**ASHRAE Addendum e to
ASHRAE Guideline 36-2024**

High-Performance Sequences of Operation for HVAC Systems

This addendum fixes errors in the equations used for FC #4 and #5 as well as removes redundant text and updates formatting for consistency with the AHU AFDD sections. Also adds clarifications on which fault conditions apply based on FCU configuration.

Revise Section 5.22.6 as follows:

Figure 5.22.6.22 FCU operating states.

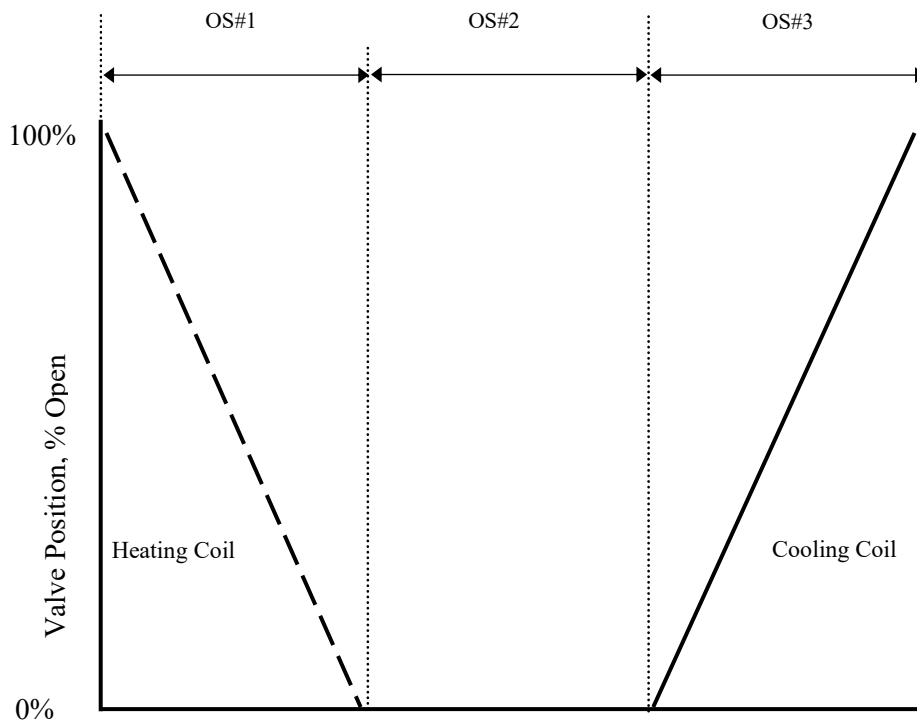
5.22.6.2. The OS of each FCU shall be defined by the commanded positions of the heating-coil control valve and cooling-coil control valve in accordance with Table 5.22.6.2 and Figure 5.22.6.2.

OS#1 through OS#3 (see Table 5.22.6.2) represent normal operation during which a fault may nevertheless occur if so determined by the fault condition tests in Section 5.22.6.5.18.13.5. By contrast, OS#4 may represent an abnormal or incorrect condition (such as simultaneous heating and cooling) arising from a controller failure or programming error.
